City of Lafayette

Staff Report

Design Review Commission

Subject: **DR13-14DDII Lennar Homes (Applicant), C-Zoning:** Request for: (1) Review of Phase II Design Plans to construct a new three-story, mixed-use development (66 for-sale residential units, 5,400-sq. ft. of commercial, and 169 on-site parking spaces) located at 3666, 3672 and 3682 Mt. Diablo Boulevard, APNs 241-020-013, 241-020-005, 241-020-008. *(The Planning Commission approved the project on March 7, 2016 subject to 61 conditions including this subsequent design review.)*

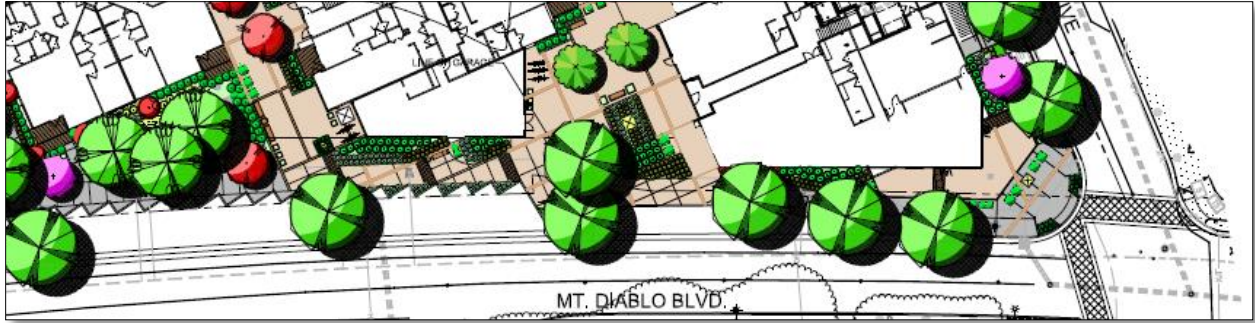
Lighting: The applicant proposes four types of lighting within the project - uplights in planters (fixture B); LED strip lights tucked up underneath planter wall caps for indirect lighting (fixture D); inset wall lights in raised planters (fixture C); and Tivoli lighting in open areas (fixture F). (See Sheet L1). No wall mounted lights or light poles are proposed.

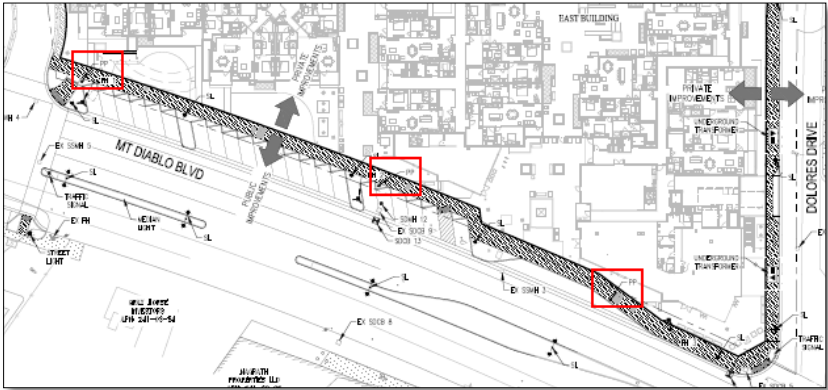
Trees: Based on direction from DSIMPIC, seven five 24" box Shumard Red Oaks and 24" box Coast Live Oaks will be planted as street trees on the boulevard and Dolores Drive respectively. A number of Crape Myrtles and Southern Live Oaks are also proposed on private property in the setback between the western building and the boulevard (See Sheets L4 and L5 for details).
